IN REPLY REFER TO:  
NCPC FILE No. 7937

<b>PROJECT</b> <b>Thomas Jefferson Memorial - Targeted Accessibility Improvements</b> 16 East Basin Drive, SW Washington, DC	<b>NCPC FILE NUMBER</b> 7937
<b>SUBMITTED BY</b> United States Department of the Interior National Park Service	<b>NCPC MAP FILE NUMBER</b> 1.51(73.10)44660
<b>REVIEW AUTHORITY</b> Approval per 40 U.S.C. § 8722(b)(1) and (d)	<b>APPLICANT'S REQUEST</b> Approval of comments on concept design
	<b>ACTION TAKEN</b> Approved comments on concept design

## Executive Director's Recommendation

## Thomas Jefferson Memorial Targeted Accessibility Improvements

## Proposed Design: Sloped Walkway outside Existing Planter

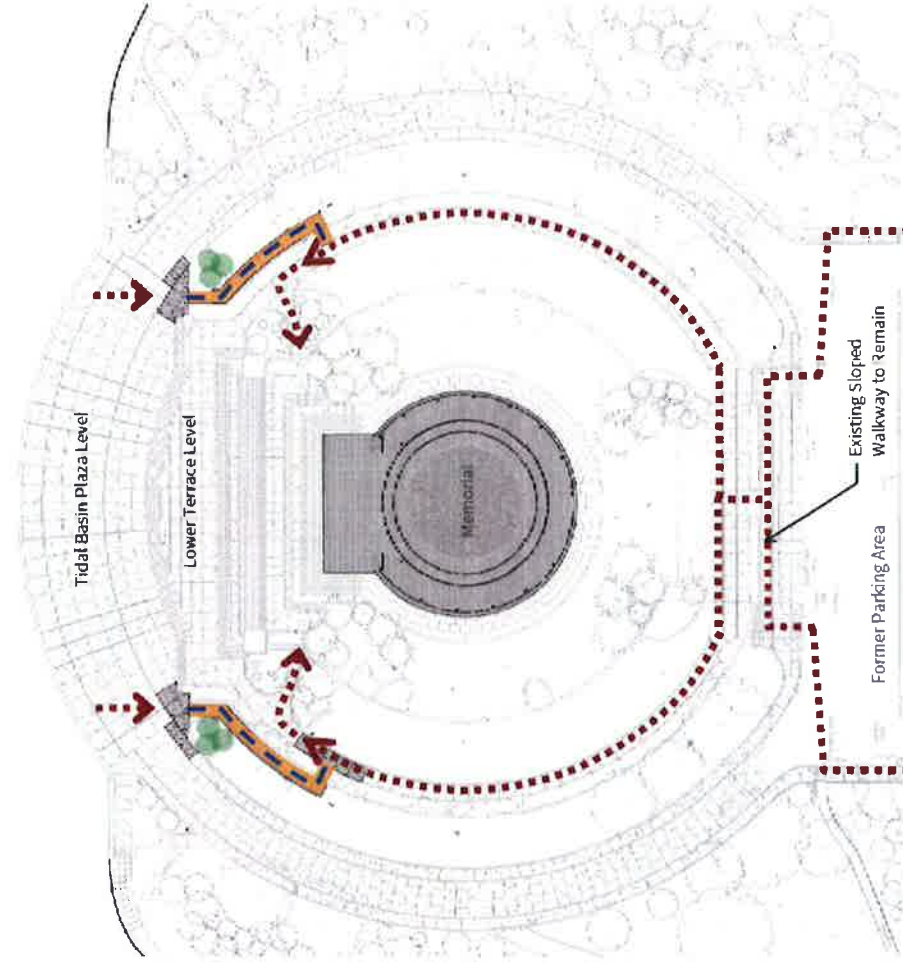
**Recommends** the applicant continue to explore their preferred design of new accessible ramps on the north side of the memorial outside the existing historic planters on the Tidal Basin Plaza level.

The U.S. Commission of Fine Arts reviewed the concept proposal at their February 15, 2018 meeting, supporting NPS's preferred option of the new accessibility ramps to be constructed outside the existing historic planters, but encouraged NPS to explore removing the external handrail by leveling the adjacent ground with the ramp and by relocating the internal handrail to the top of the historic terrace planter.
